**SUBDIVISION,  
PLANNED UNIT DEVELOPMENT,  
PLANNING APPROVAL, &  
REZONING STAFF REPORT**

**Date: November 17, 2011**

<b><u>APPLICANT NAME</u></b>	Zion Baptist Church
<b><u>SUBDIVISION NAME</u></b>	Zion Baptist Church Subdivision
<b><u>DEVELOPMENT NAME</u></b>	Zion Baptist Church Subdivision
<b><u>LOCATION</u></b>	2514 Halls Mill Road (Northwest corner of Halls Mill Road and Pollard Lane)
<b><u>CITY COUNCIL DISTRICT</u></b>	Council District 4
<b><u>PRESENT ZONING</u></b>	R-1, Single Family Residential & B-3, Commercial Business District
<b><u>PROPOSED ZONING</u></b>	R-1, Single-Family Residential District
<b><u>AREA OF PROPERTY</u></b>	5.6± Acres
<b><u>CONTEMPLATED USE</u></b>	<p>Subdivision Approval to create two legal lots of record from an existing two legal lots of record and two metes and bounds parcels; Planned Unit Development to allow multiple buildings on a single building site, Planning Approval to allow an existing church in an R-1, Single-Family Residential District, and rezoning from R-1, Single-Family Residential District and B-3, Community Business District, to R-1, Single-Family Residential District and to eliminate split zoning in a proposed subdivision.</p> <p

## SITE PLAN

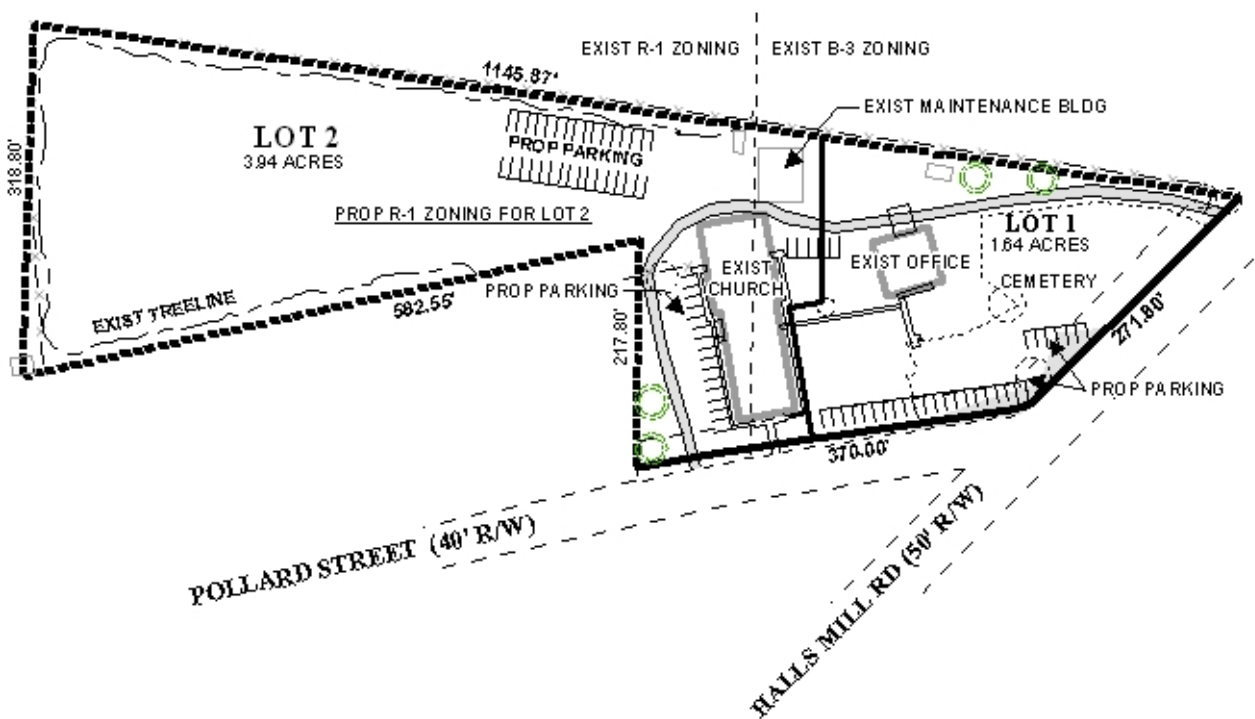
*Revised: Driveway number, size, location and design to be approved by Traffic Engineering and conform to AASHTO standards. As shown, the 10' asphalt drive is not wide enough to accommodate two-way traffic. A 14'-16' aisle is the minimum desirable width to designate an entrance as one-way. Also the gate at Halls Mill Road may prohibit circulation through the site if it is common practice to keep the gate closed or locked. Two-way traffic cannot occur between the maintenance building and the church; one-way traffic is very constrained. Parking stalls along Pollard Street are not accurately depicted in the site plan. Several of the "stalls" are less than 20' from the edge of the roadway. Any parking that requires backing into the right-of-way or parking within the right-of-way is not recommended. Excess asphalt and/or gravel surfaces within the right-of-way that are not permitted to be utilized as parking through a right-of-way use agreement should be removed. There is no existing designated handicap parking and the site plan does not show adequate facilities to account for handicap accessibility (for example, proper parking stall size, aisles and solid surface access to the structures).*

*The applicant submitted revised detailed site plans; however, the plans illustrate several issues associated with the safety and welfare of the congregation of the church. The site plan illustrates approximately 23 parking spaces providing maneuvering within the right-of-way along Pollard Street and within the intersection of Halls Mill Road and Pollard Street; therefore, these parking spaces should be eliminated due to the proximity within the right-of-way. As the site plan submitted by the applicants, proposed Lot 2 provides ample space to provide the required parking for the church and the associated cemetery located on Lot 1. As stated in Traffic Engineering comments, "the 10' asphalt drive is not wide enough to accommodate two-way traffic. A 14'-16' aisle is the minimum desirable width to designate an entrance as one-way. Also the gate at Halls Mill Road may prohibit circulation through the site if it is common practice to keep the gate closed or locked. Two-way traffic cannot occur between the maintenance building and the church; one-way traffic is very constrained. Parking stalls along Pollard Street are not accurately depicted in the site plan. Several of the "stalls" are less than 20' from the edge of the roadway. Any parking that requires backing into the right-of-way or parking within the right-of-way is not recommended. Excess asphalt and/or gravel surfaces within the right-of-way that are not permitted to be utilized as parking through a right-of-way use agreement should be removed. There is no existing designated handicap parking and the site plan does not show adequate facilities to account for handicap accessibility (for example, proper parking stall size, aisles and solid surface access to the structures)."*

*As stated in the analysis provided by the applicant the seating capacity for the sanctuary is 300 seats. The Zoning Ordinance requires 75 parking spaces for 300 seats, and 76 parking spaces are depicted on the site plan. The proposed number of parking spaces meets the minimum*

requirements; however, as previously stated several do not comply, as they back out into the right-of-way. Therefore, the provision of compliant parking spaces (75) and surface should be provided on Lot 2.

Also illustrated on the site plan are several large Live Oak trees located within the existing parking and/or maneuvering areas, which as noted from Urban Forestry comments, should be given preservation status and protected from removal or the continued compaction of the root system by the parking of vehicles. Therefore, the removal of parking spaces and maneuvering should be required within the critical root zone of all trees designated preservation status.

- 1) submittal of an acceptable, detailed narrative describing the project in detail as required in Section 64-5.D. of the Zoning Ordinance;
- 2) revision of the site plan to show **ALL** required parking spaces on Lot 2, including, but not limited to, dimensions of parking stalls or drive aisles, indicate paving materials, and indicate the seating capacity of the church and other information needed to ensure parking compliance;

- 5) compliance with Traffic Engineering Comments: "Driveway number, size, location and design to be approved by Traffic Engineering and conform to AASHTO standards. As shown, the 10' asphalt drive is not wide enough to accommodate two-way traffic. A 14'-16' aisle is the minimum desirable width to designate an entrance as one-way. Also the gate at Halls Mill Road may prohibit circulation through the site if it is common practice to keep the gate closed or locked. Two-way traffic cannot occur between the maintenance building and the church; one-way traffic is very constrained. Parking stalls along Pollard Street are not accurately depicted in the site plan. Several of the "stalls" are less than 20' from the edge of the roadway. Any parking that requires backing into the right-of-way or parking within the right-of-way is not recommended. Excess asphalt and/or gravel surfaces within the right-of-way that are not permitted to be utilized as parking through a right-of-way use agreement should be removed. There is no existing
